August 28, 2001
NUH03-01-1722

Subject: Supplemental Thermal Calculations and Supporting ANSYS Input Files for
Amendment No.5 of NUHOMS® Certificate of Compliance No. 1004 for Dry
Spent Fuel Storage Casks

Supplemental Thermal Calculations

Figure 1 Closed cavity convection model

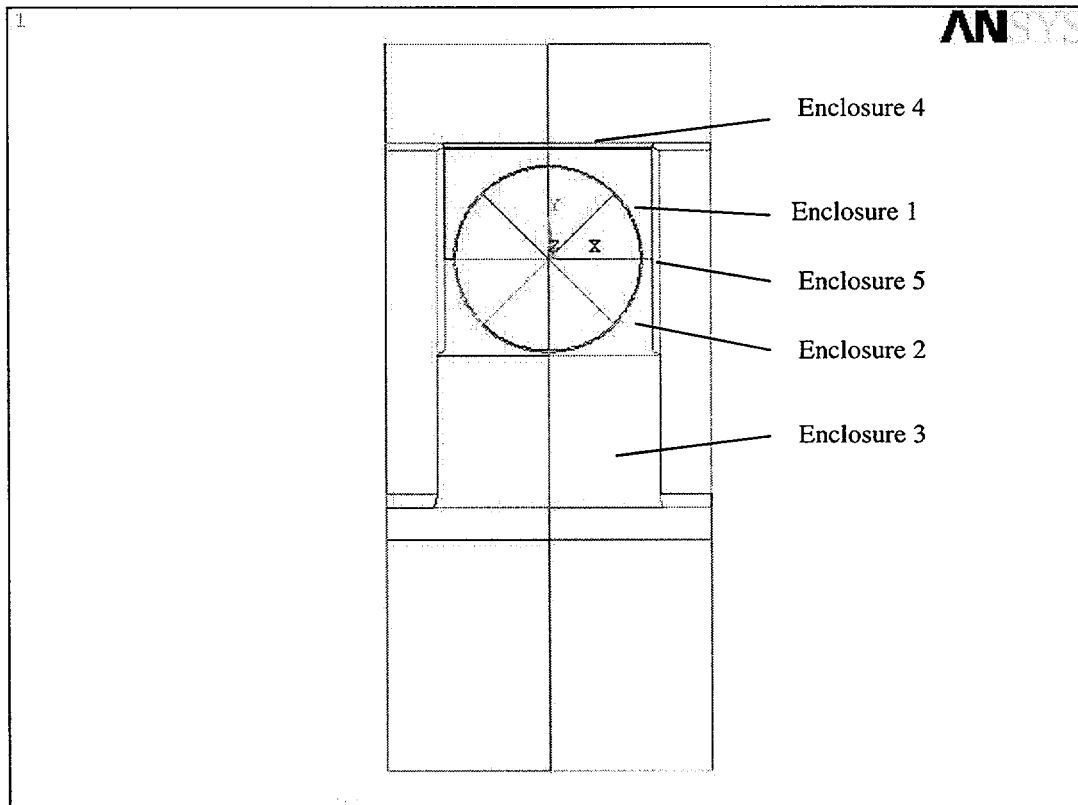
Item 4: Provide additional description of “Closed Cavity Convection” modeling technique to include graphical representation of the zones used for the model and electronic files of any computer models used.

In order to evaluate the thermal effect of closed cavity convection of air within the HSM on DSC shell temperatures, the HSM cavity surrounding the DSC is divided into 5 enclosures as shown in Figure 1 below.

The bottom border of the bottom inclined enclosure 2 - the free surface - can be considered as solid for mean temperature evaluation. Interference of flows in enclosures 1 and 2 is expected to be negligible, since enclosure 1 is heated from below and enclosure 2 from the top.

Convection within enclosure 3 is conservatively neglected, since the rectangular annulus heated from the top does not experience noticeable free thermal convection. Convection and conduction in the air are combined into an effective thermal conductivity value for each enclosure, based on temperature difference, geometry and flow regime. The analysis considered the geometry and thermal convection conditions for each particular enclosure. Irregular enclosures 1 and 2 were represented by inclined (45° and -45° , respectively) flat rectangular annuluses. Inclination correction coefficients were applied.

Effective thermal conductivity of the air within closed cavity convection enclosures is evaluated by hand calculations. Excel spreadsheet (32p_Black_Vent_Conv.xls) and copies of ANSYS HSM and DSC input files (BL_Vent_Conv_32PT.txt, sd32_blk_alt_it2.txt) are provided in the attached CD.
